BOARD OF EDUCATION – REGULAR MEETING

b) Madison Change Order No. G-6 - \$9,957.00

Date: 08/20/15
 Project: Madison Elementary School Addition & Renovation/ 1277A
 Subject: Architect's Proposal/Change Order Log

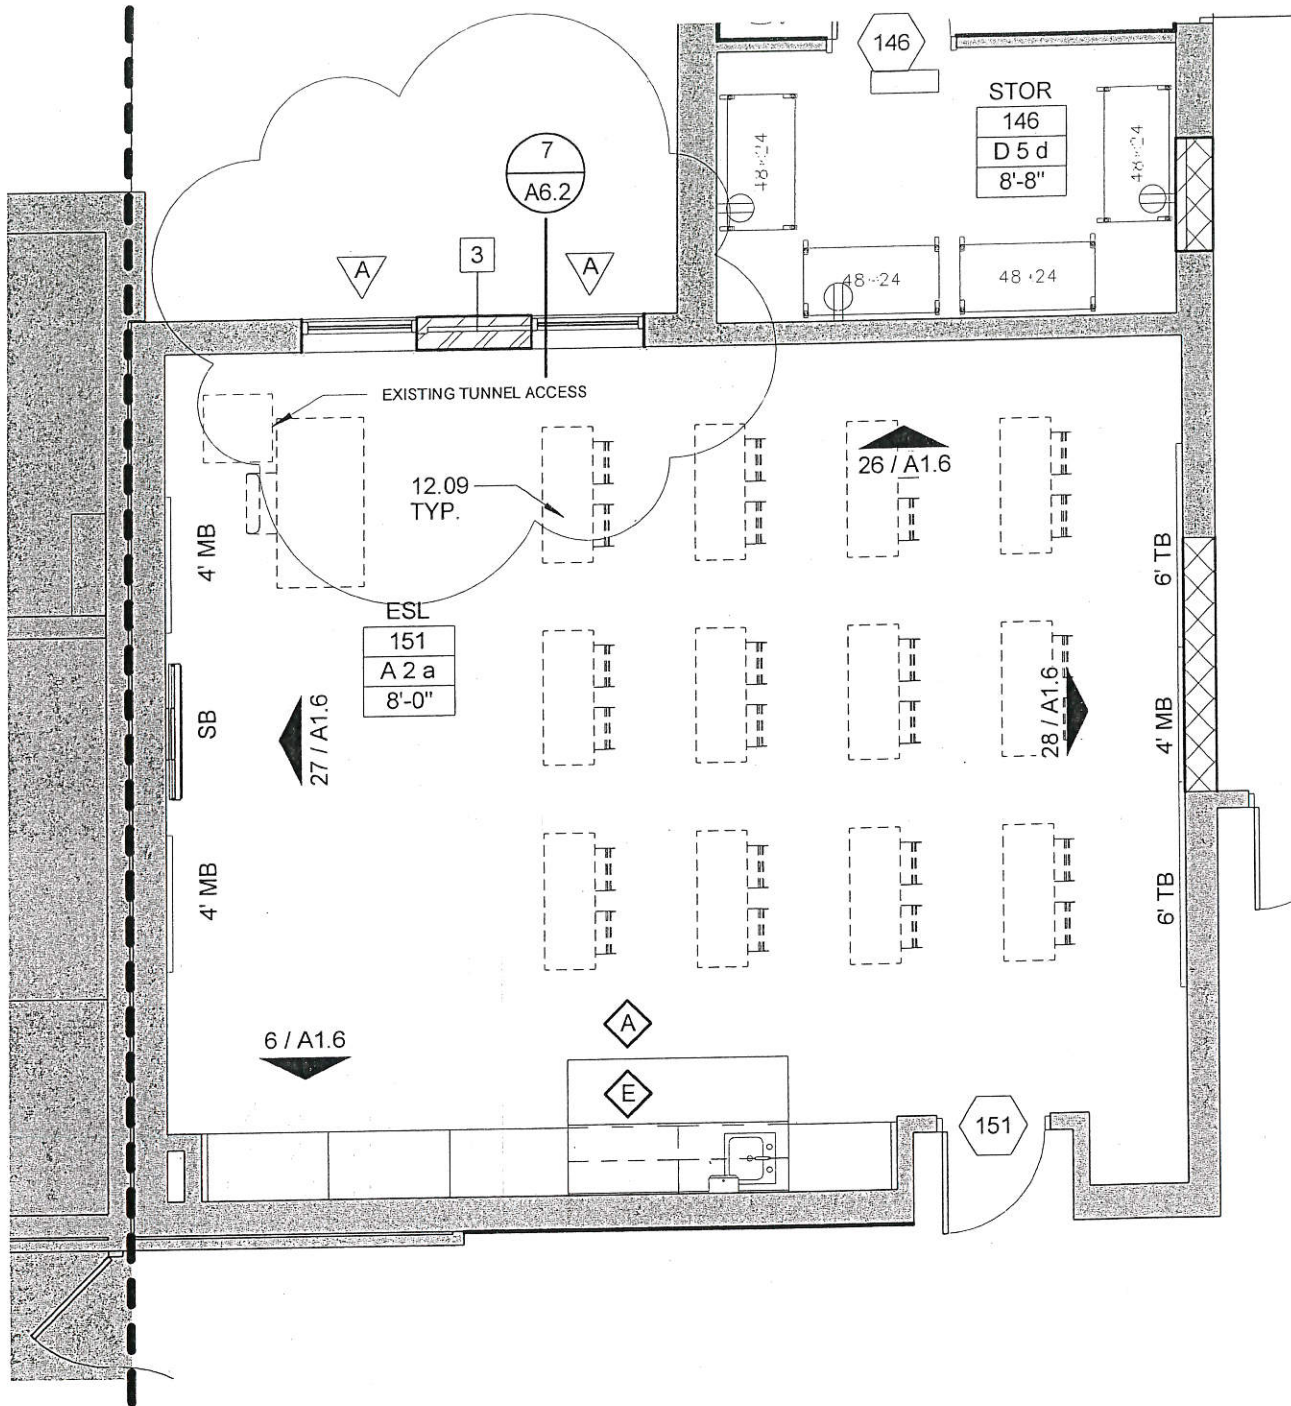
1. Provide an itemized proposal for installing an additional Window Type A in Room 151. In the existing opening, place the wall infill between the windows being installed.
2. See attached.

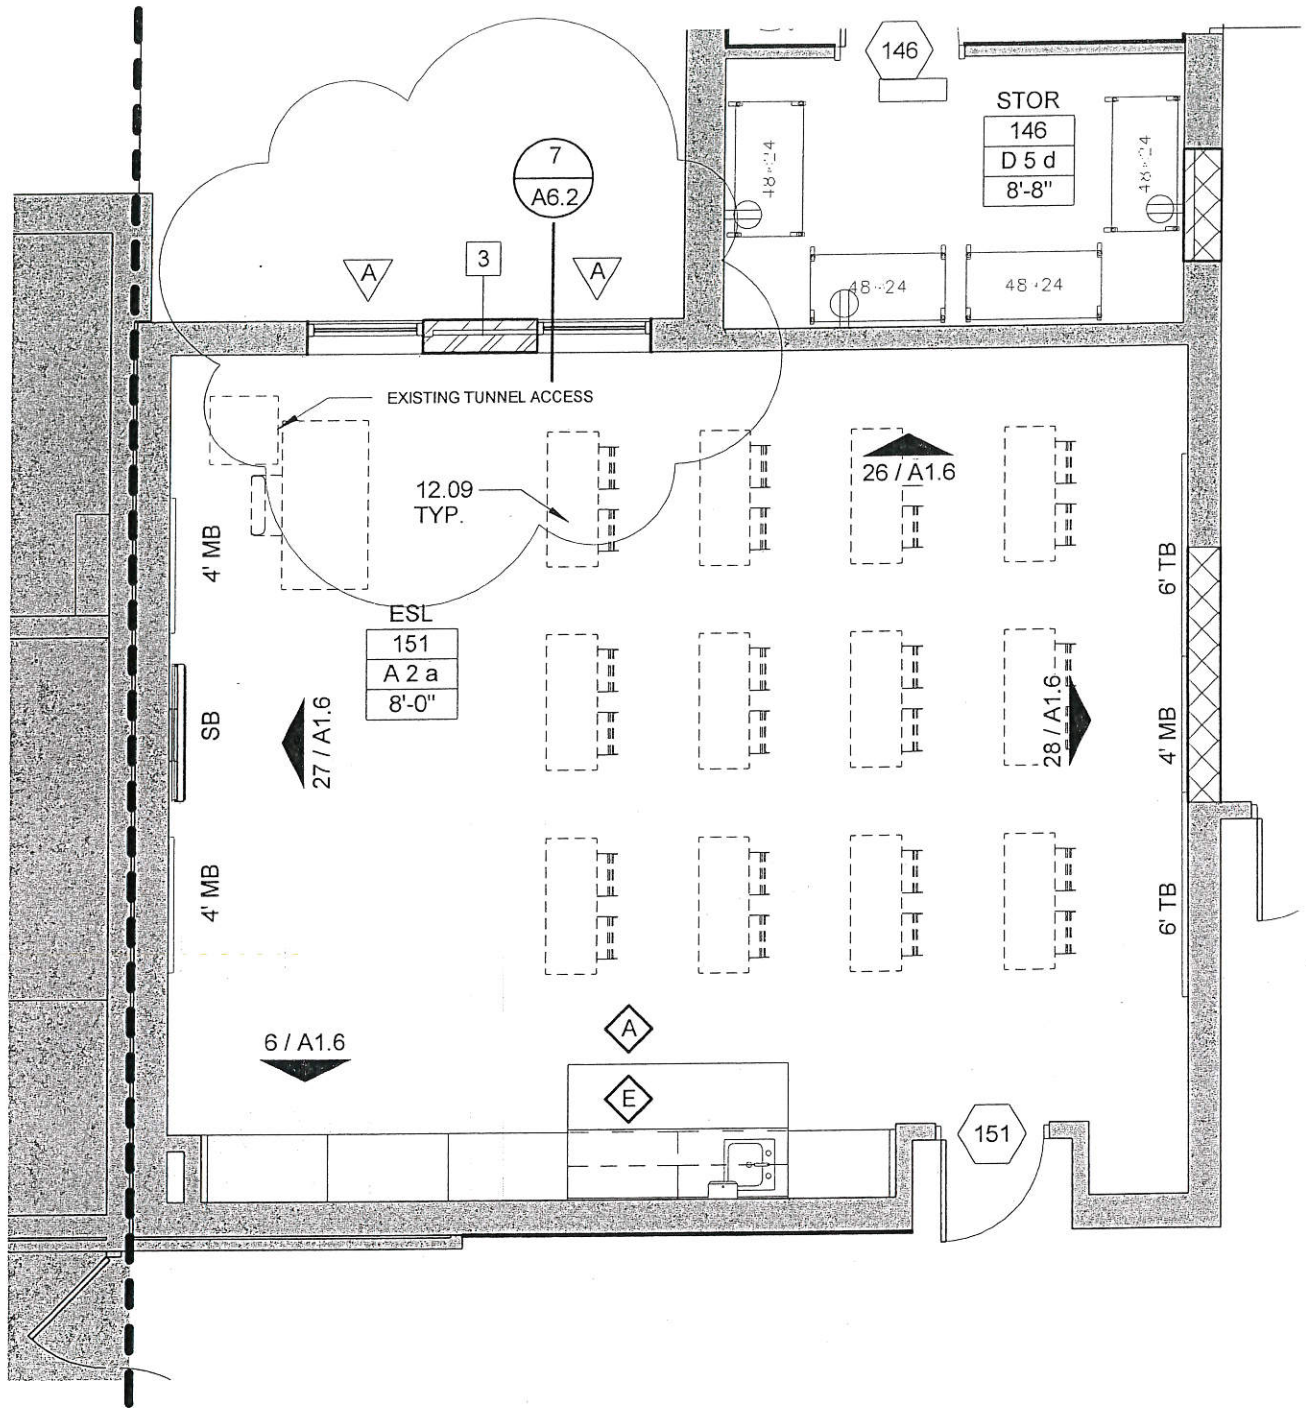
1. Provide an itemized proposal for installing an additional Window Type A in Room 151. In the existing opening, place the wall infill between the windows being installed.
2. See attached.

MAIN ENTRY - ADDED GYPSUM - AREA B
 $3/32" = 1'-0"$

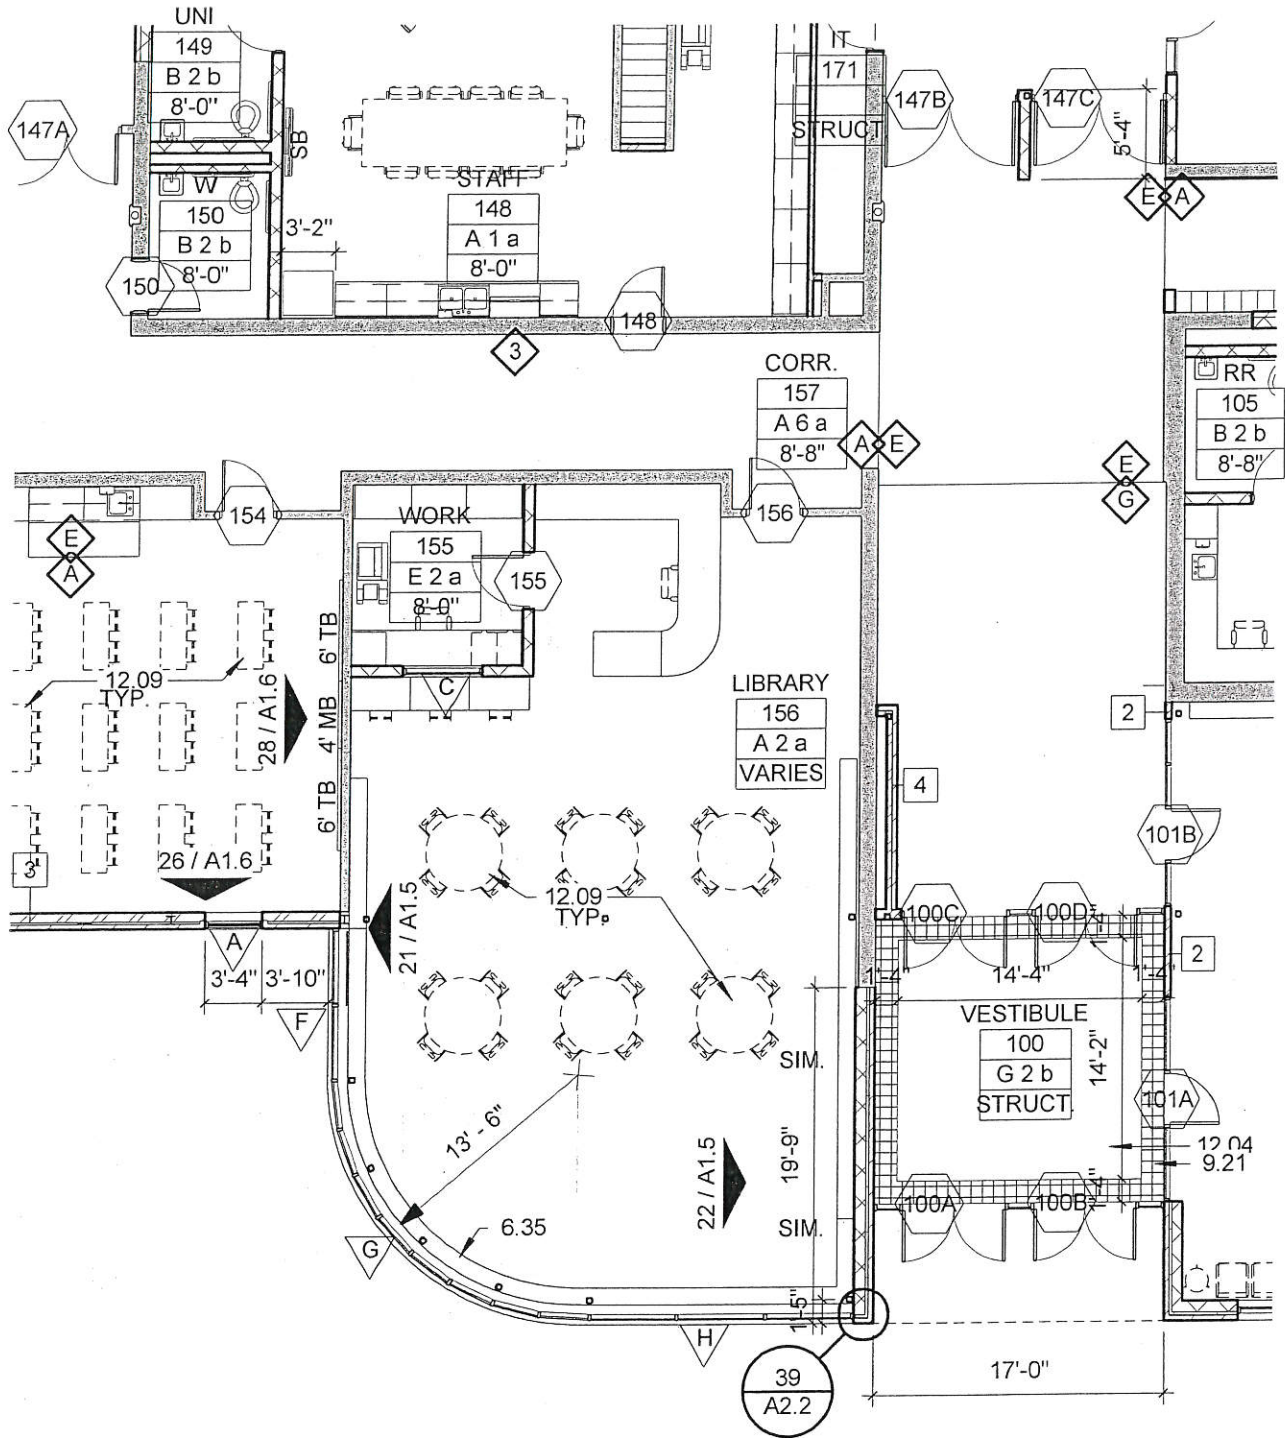
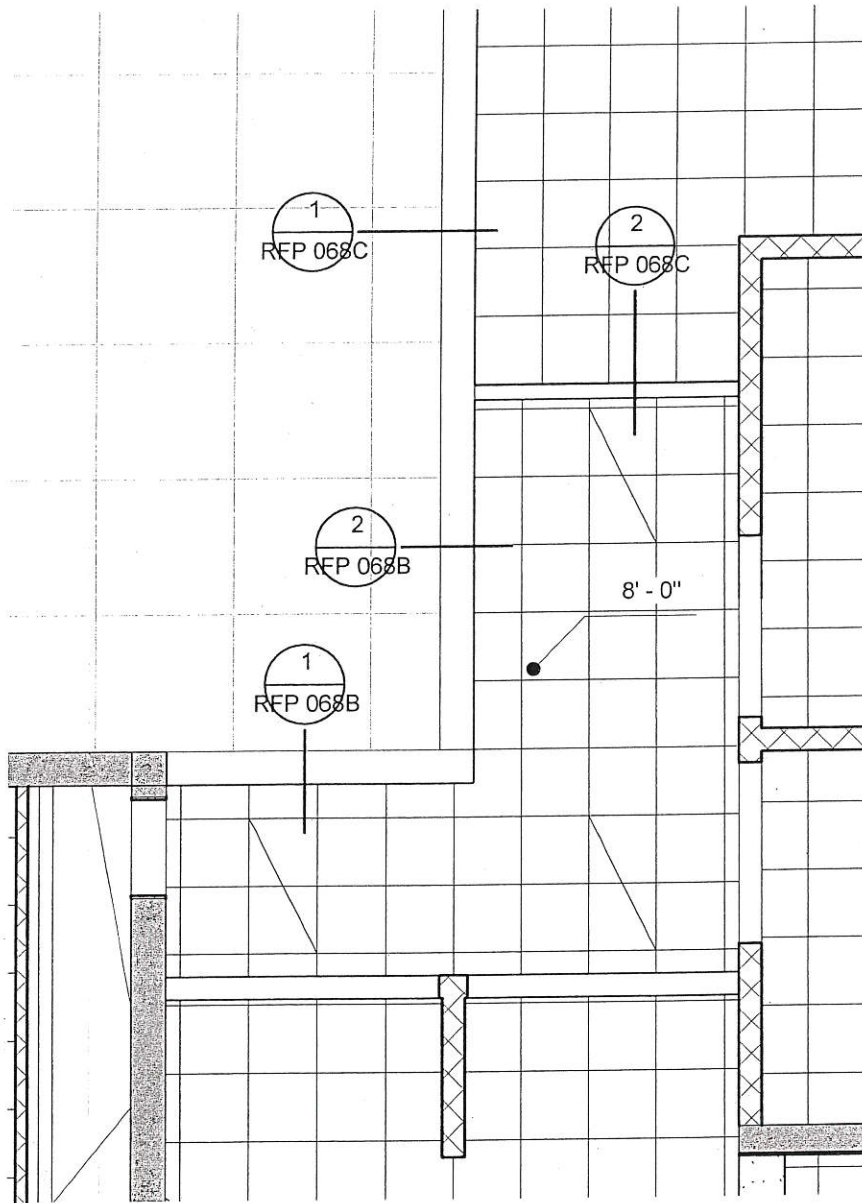
- H. Material/Labor Cost to add metal stud wall that is located north of Door #101B/adjacent to Vestibule #100. 168 sq. ft.
- I. Material/Labor Cost to patch and repair existing drywall Room #148.

- P. Material/Labor Cost to delete the 2 soffits at Door #'s 147B and 147C and one in Commons 147. North of Room #128 and add the beam wrap as shown on the attached 3 drawings.

MAIN ENTRY - ADDED GYPSUM - AREA B

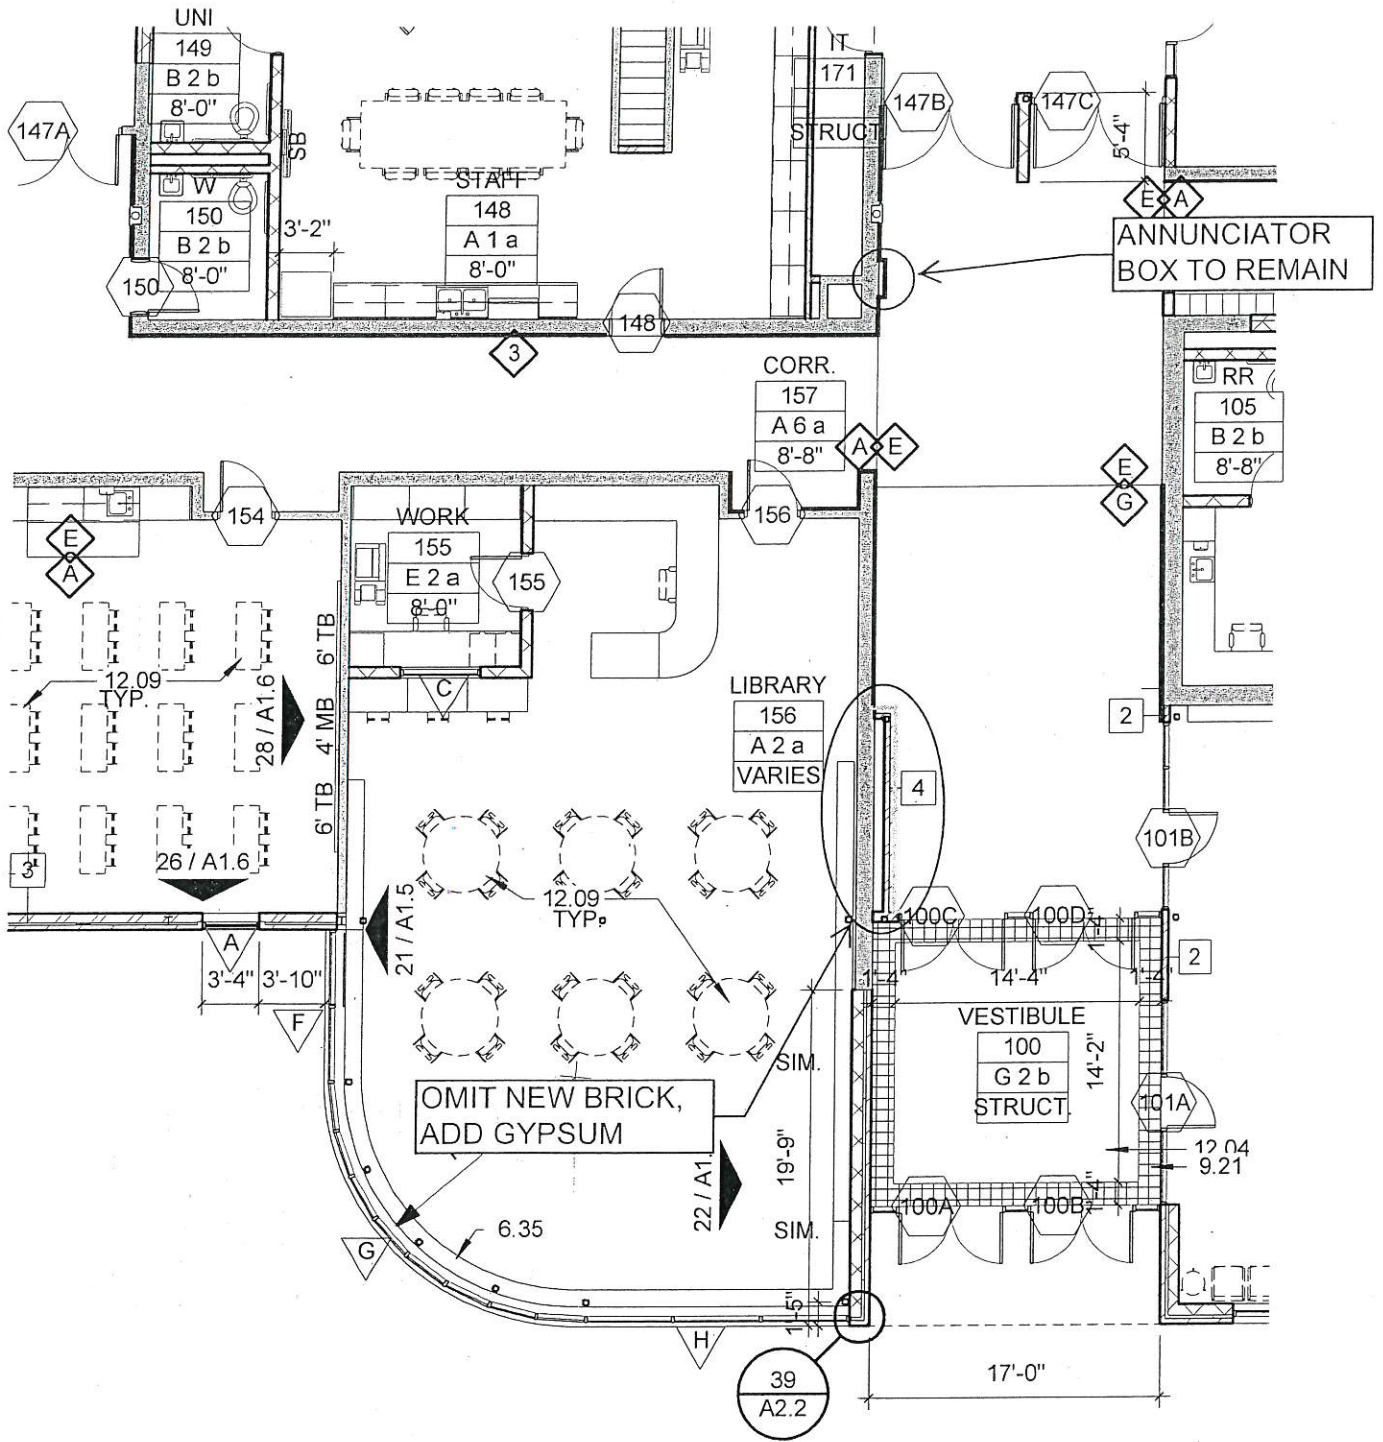
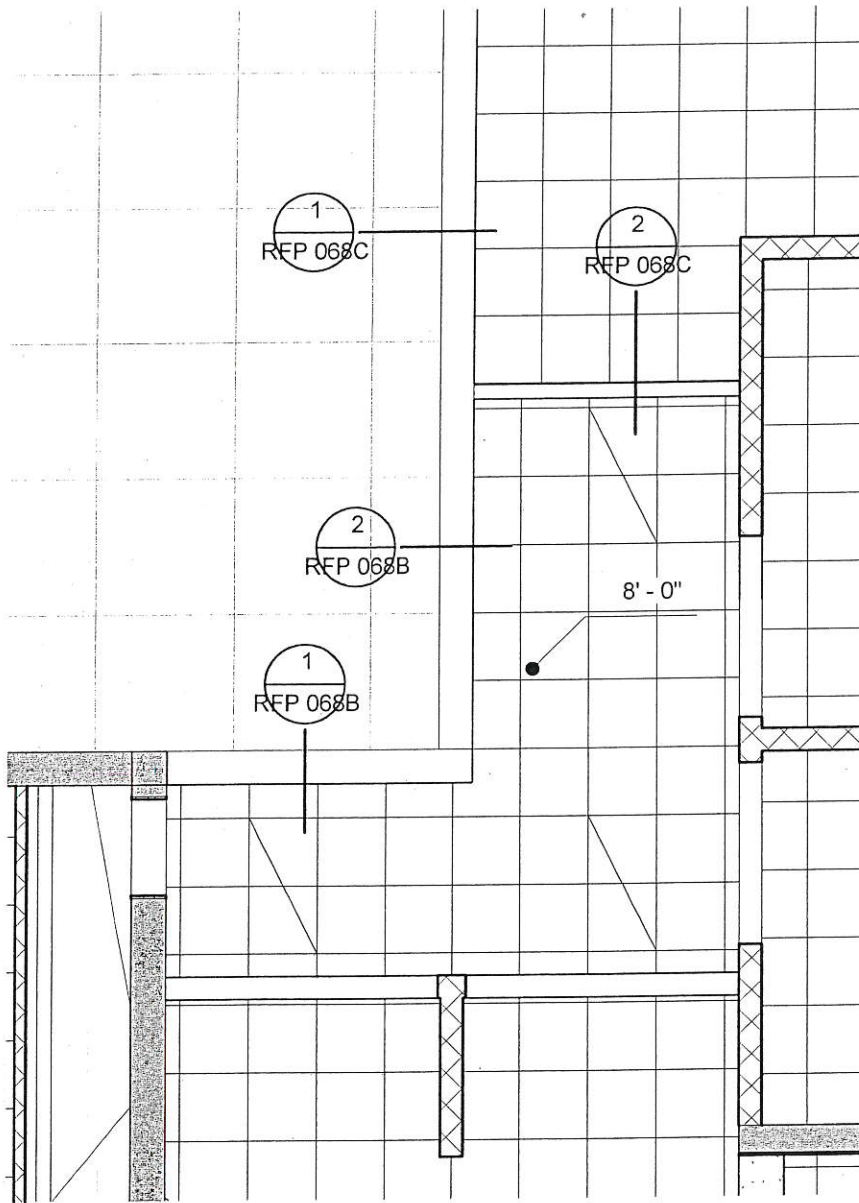
- H. Material/Labor Cost to add metal stud wall that is located north of Door #101B/adjacent to Vestibule #100. 168 sq. ft.
- I. Material/Labor Cost to patch and repair existing drywall Room #148.

- P. Material/Labor Cost to delete the 2 soffits at Door #'s 147B and 147C and one in Commons 147. North of Room #128 and add the beam wrap as shown on the attached 3 drawings.
